BROOKSIDE GOLF COURSE IMPROVEMENTS PROJECT

INITIAL STUDY/MITIGATED NEGATIVE DECLARATION RESPONSE TO COMMENTS

MAY 2023

MINIATURE GOLF ANALYSIS

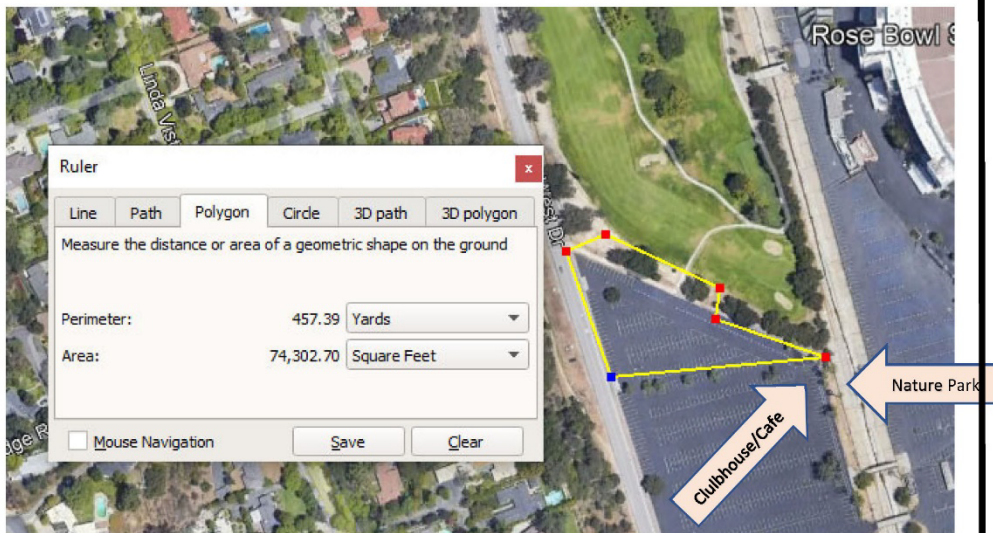
Challenging elements of the proposed miniature golf course at the western edge of the existing driving range are:

- The location is more than one-quarter mile from the prime parking area which is too far and would likely negatively impact long-term utilization
- The prime parking lot is heavily utilized and the additional volume of users would exacerbate the current situation
- The facility would have no exposure and an unattractive entryway along the driving range stalls
- The design does not include any additional amenities to make this an attractive recreational opportunity
- The overall benefit to the general public is minimal

DRIVING RANGE ANALYSIS

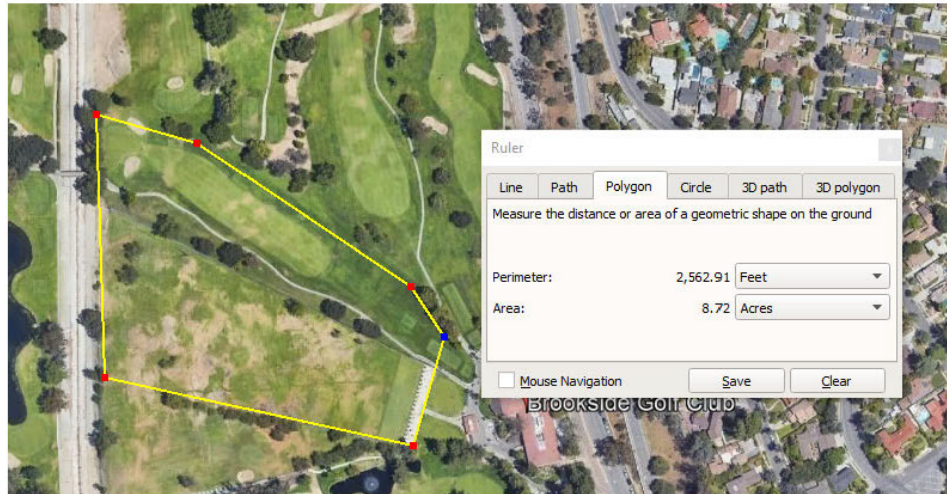
Challenging elements of the proposed driving range are:

- The negative impact on the E.O. Nay course is severe and the 6th hole as it exists is unique and should not be altered
- The proposed tree removal is extensive and unnecessary
- Lighting the driving facility is not compatible with the historic use or public benefit

R16-6

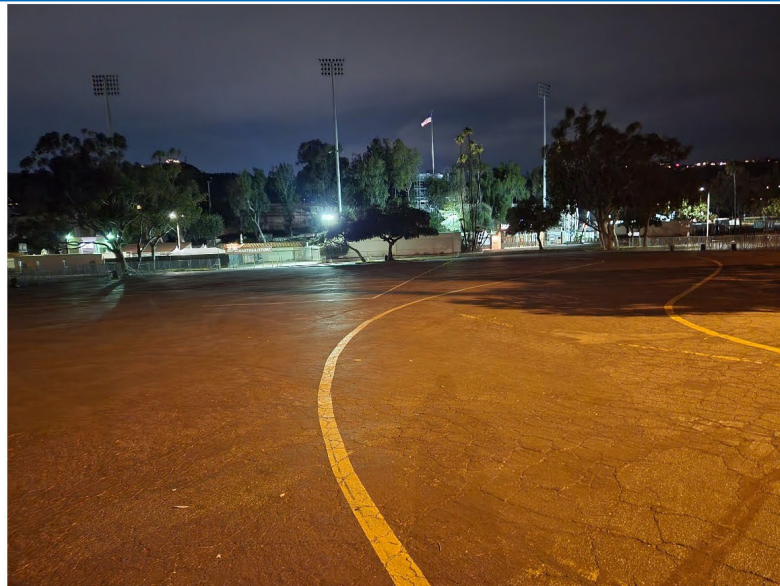
- The first three photographs demonstrate the extensive ambient light from fixtures at the Rose Bowl and associated parking lots.
- The 4th and 5th photographs show that the golf course is effectively dark beyond the lighting at the clubhouse and surrounding structures (the light in the driving range photograph is a maintenance worker on a tractor collecting balls).

Attachment C: Existing Lighting at Brookside Golf Course

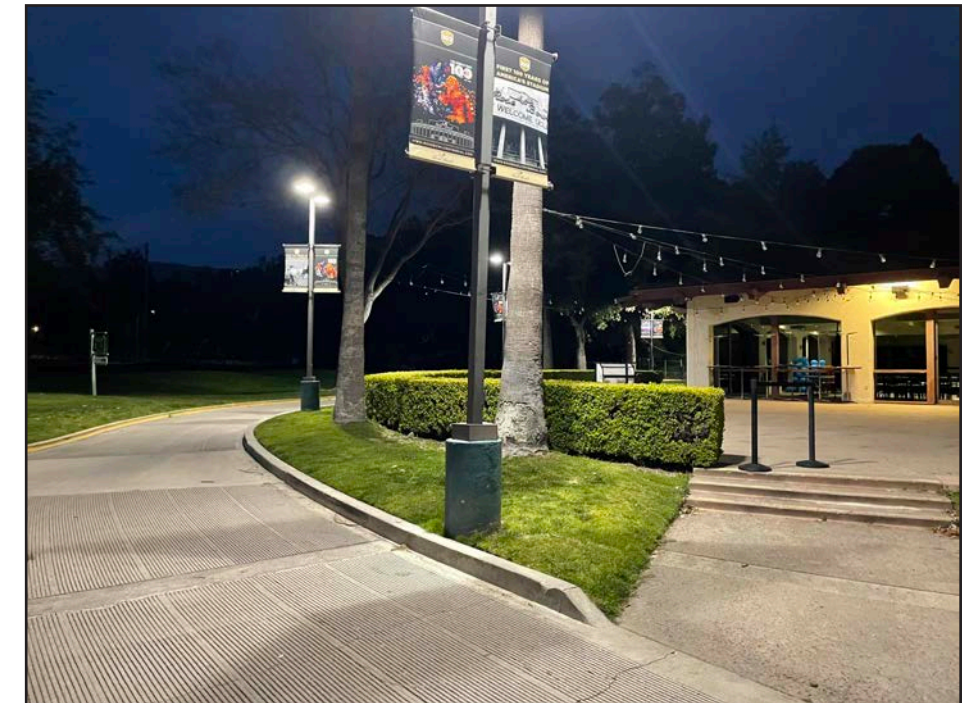
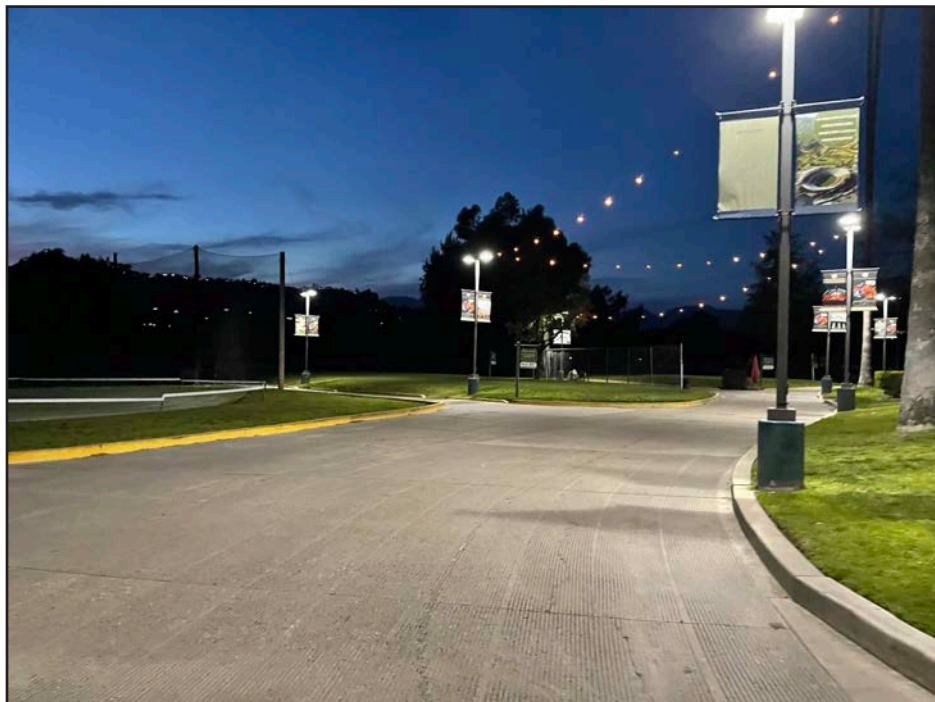
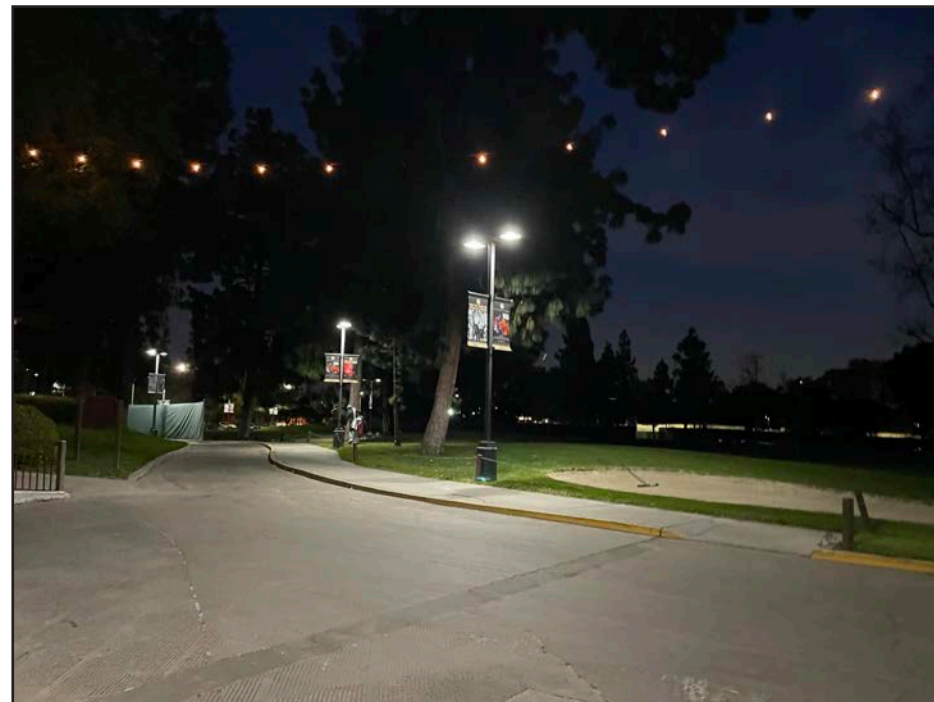
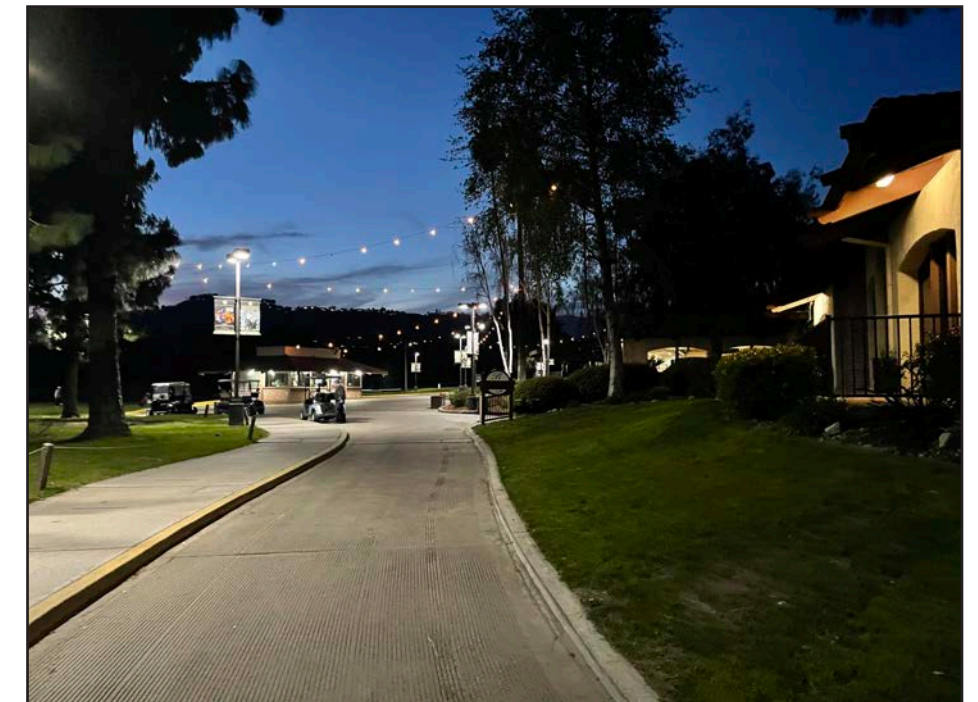
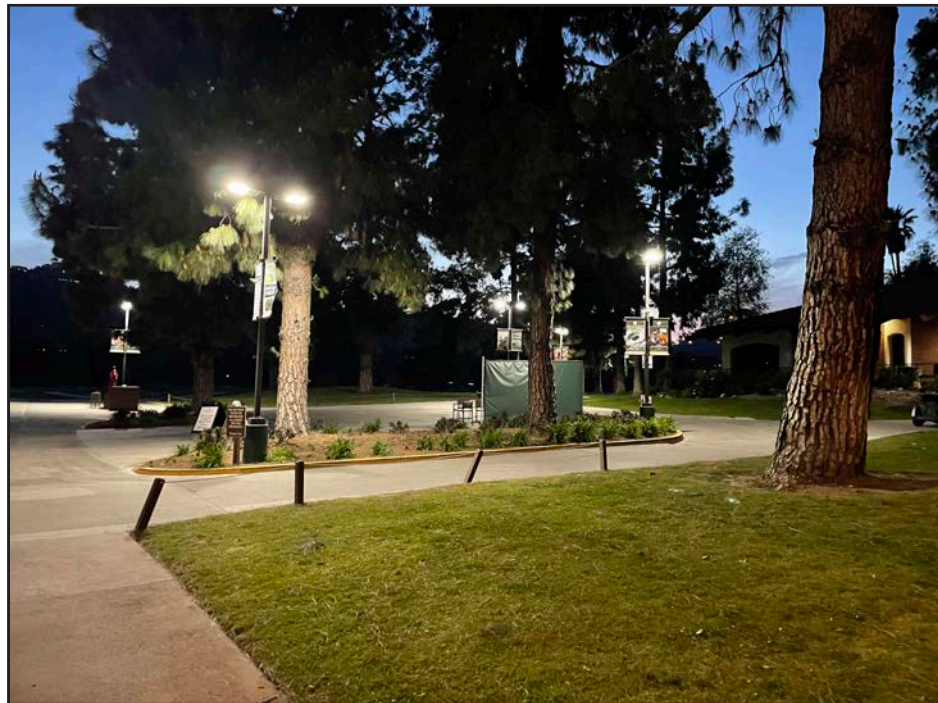
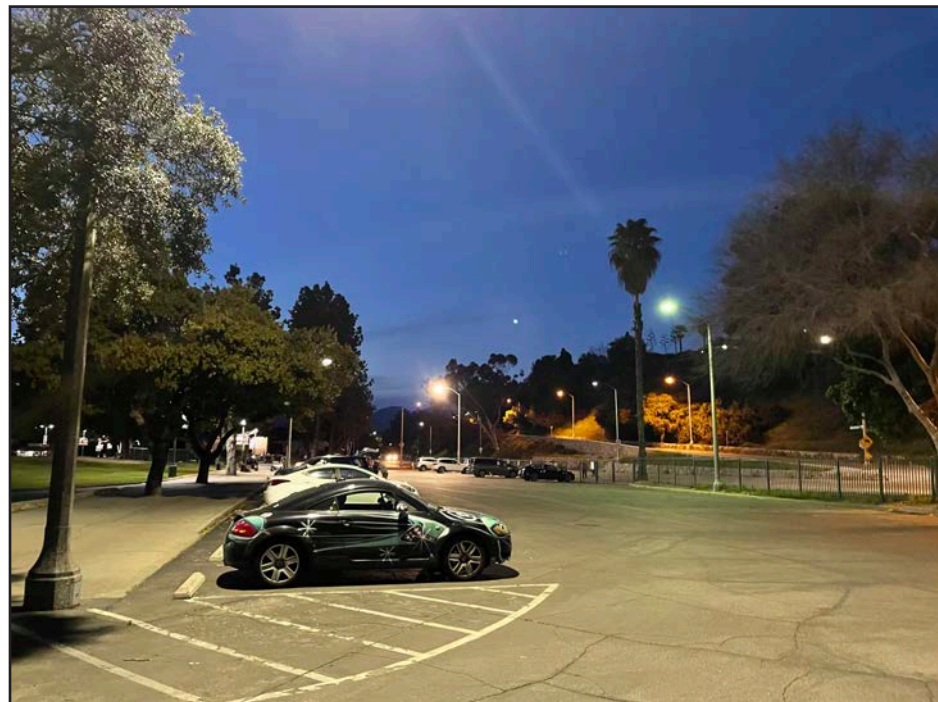
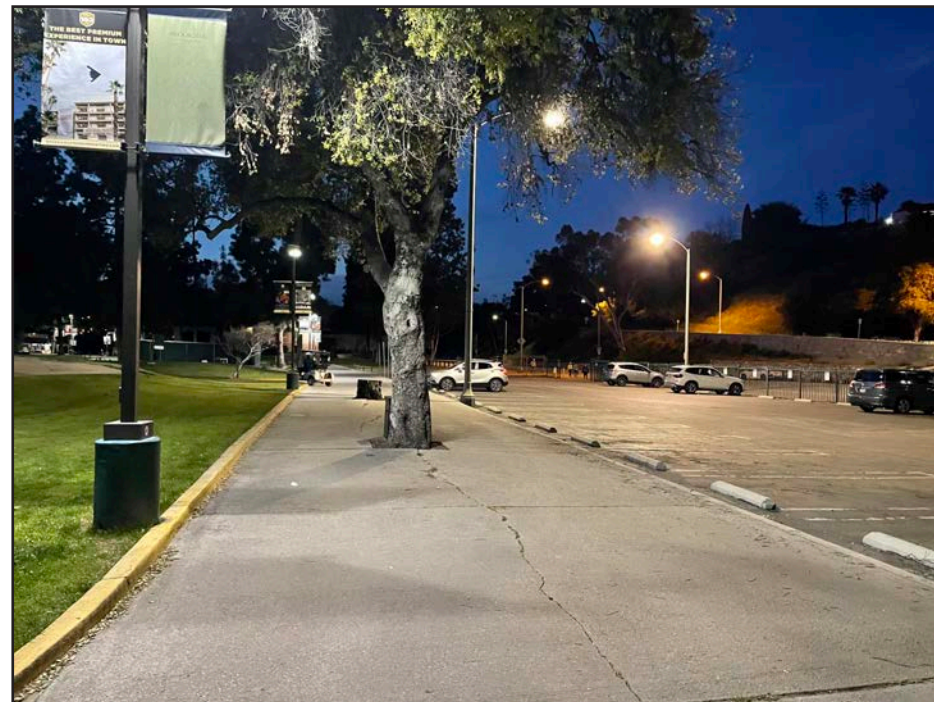
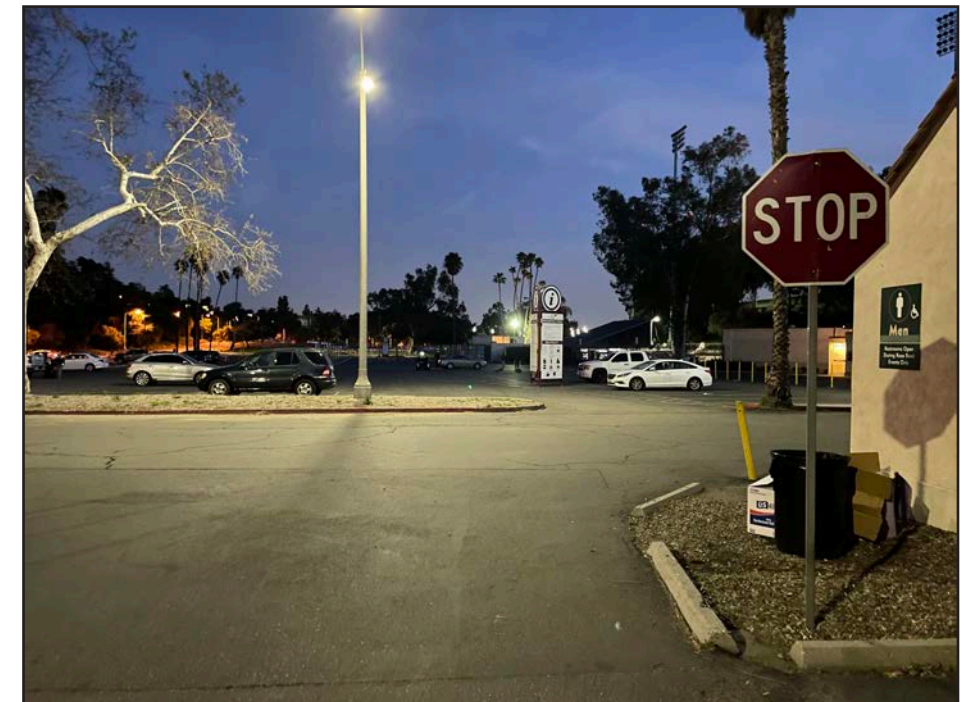
Additionally, comments assert that with the implementation of new operational hours for the driving range and miniature golf course, Brookside Golf Course does not provide sufficient lighting to ensure pedestrian safety in areas surrounding the Project Site, including walkways and parking lots.

With respect to public safety in the Project Site and the surrounding areas, Attachment C shows that walkways and parking lots leading to and from the existing driving range provide sufficient lighting to ensure the safety of visitors and staff that exit the Brookside Golf Course after sunset, in current conditions.
